PUR-1577

ADDENDUM NO. 3  
INVITATION TO BID

WASHINGTON COUNTY PUMP STATION UPGRADES

DATE: Monday, November 14, 2022

## ***TYPICAL DOUBLE SWING GATE***

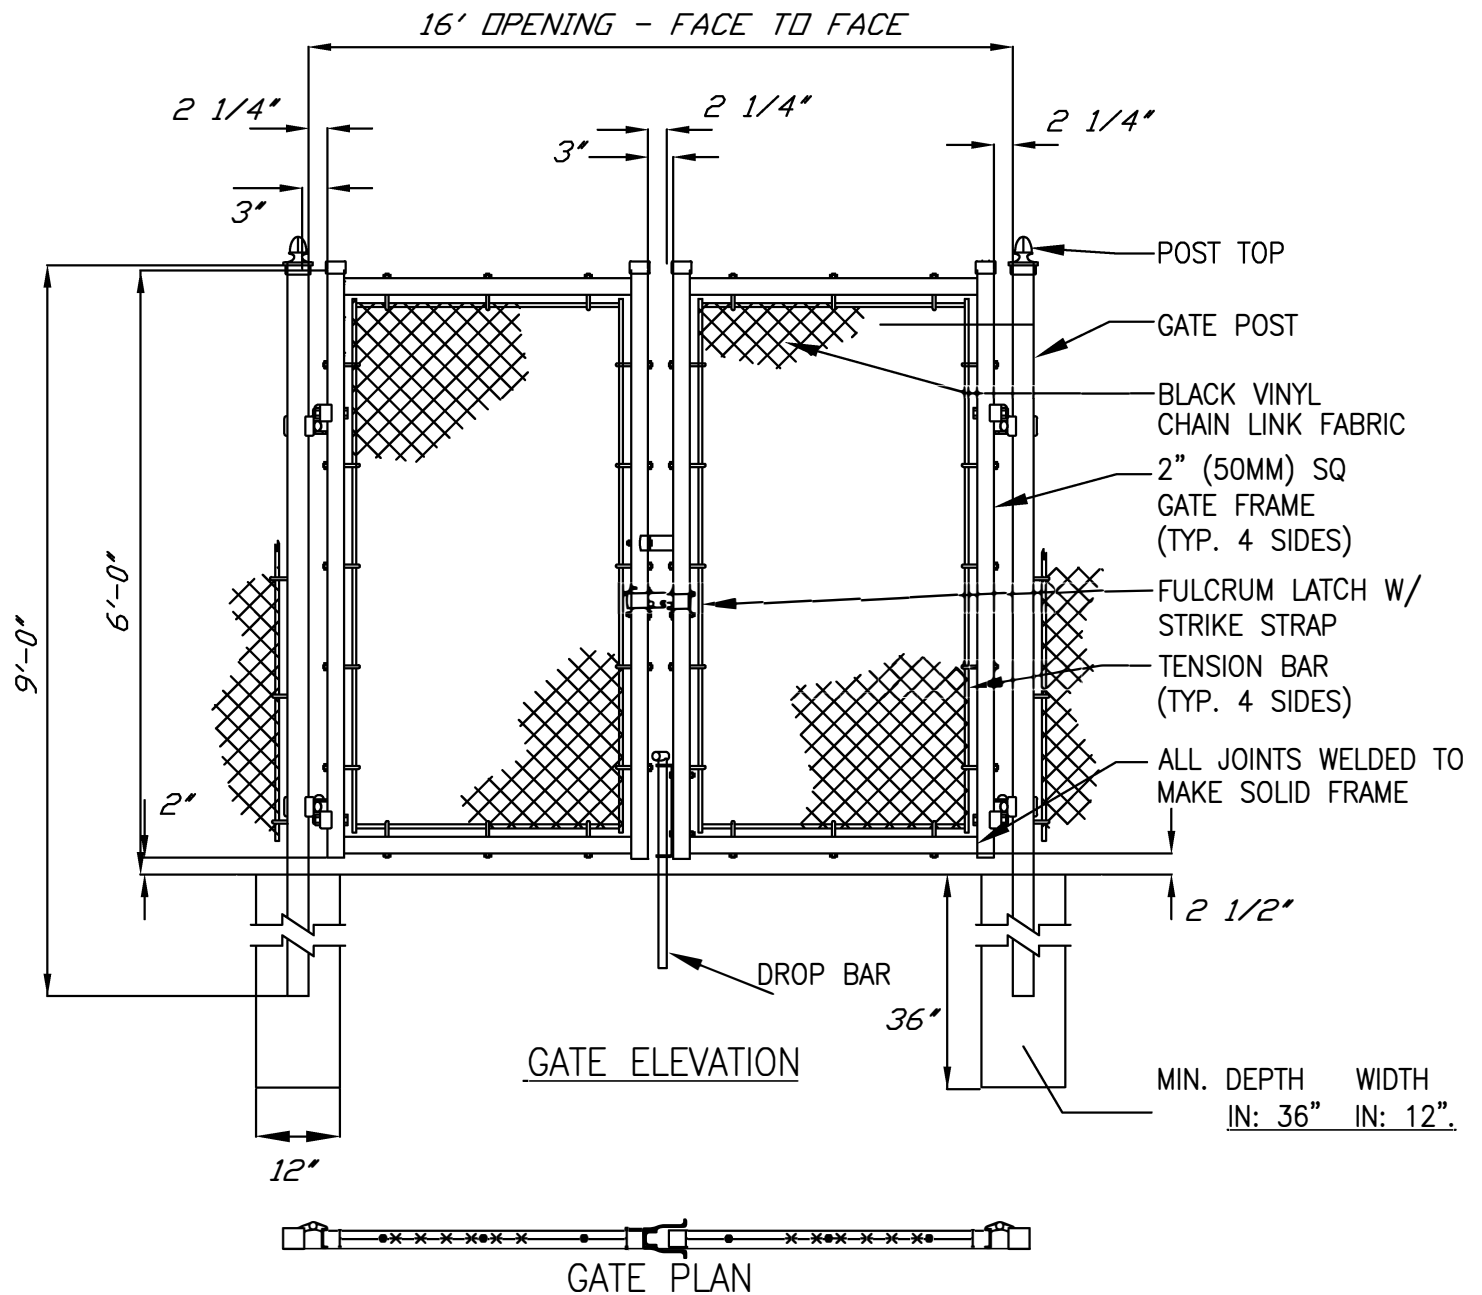
**ITEM NO. 20:** *Inquiry:* Can you please provide details and specifications for the new fence that is to go around the New Regional Pump Station and the Farm Lane Pump Station?

**ITEM NO. 26:** Inquiry: Please provide details and specifications for the fencing shown at the New Regional Pump Station.

*Response:* Contractor shall reference the fencing details in Attachment A of this Addendum.

Response: Contractor shall reference the fencing details in Attachment A of this Addendum.

**TYPICAL HIGH FENCE WITH TOP RAIL**

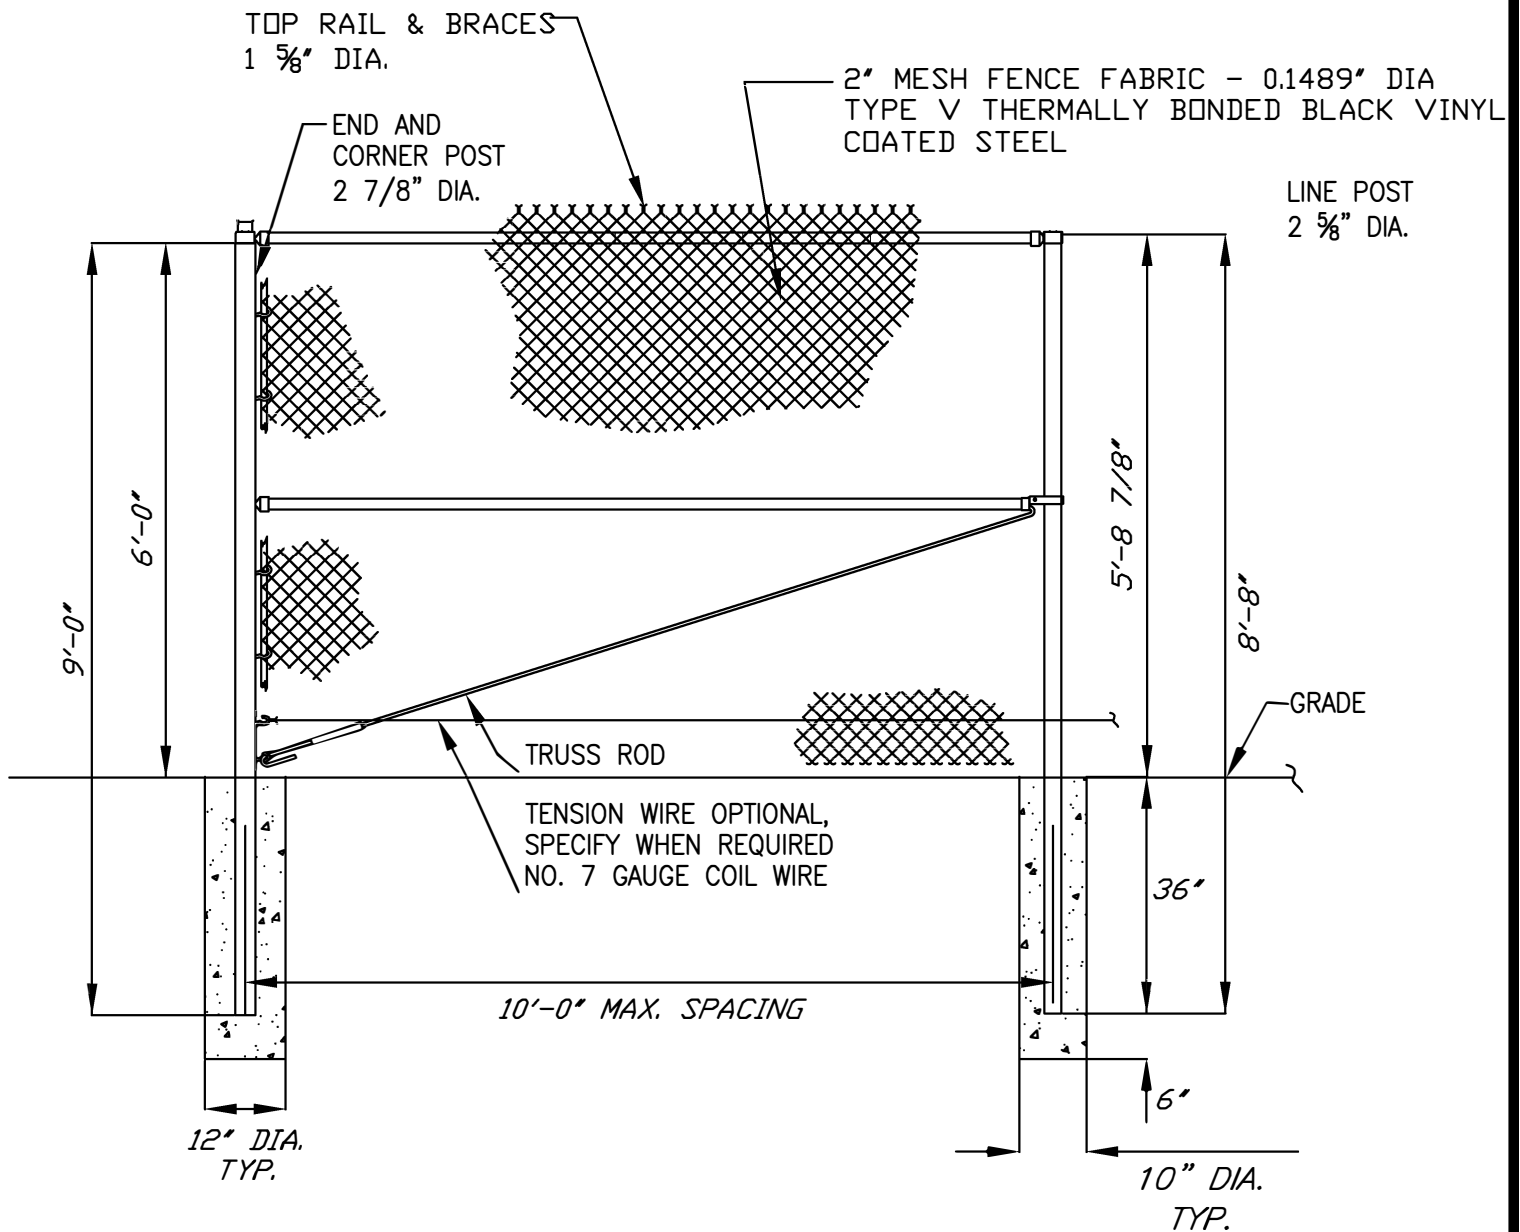
**ITEM NO. 2:** Inquiry: Please clarify the size, type, and preferred model/manufacture of permanent fencing to installed at each pump station.

Response: In accordance with County's Specification Section 213 Paragraph M., fencing removed and replaced shall be restored to the condition equal to, or better than existed prior to start of the work. Where fencing was not previously installed, Contractor shall reference the fencing details in Attachment A of this Addendum.
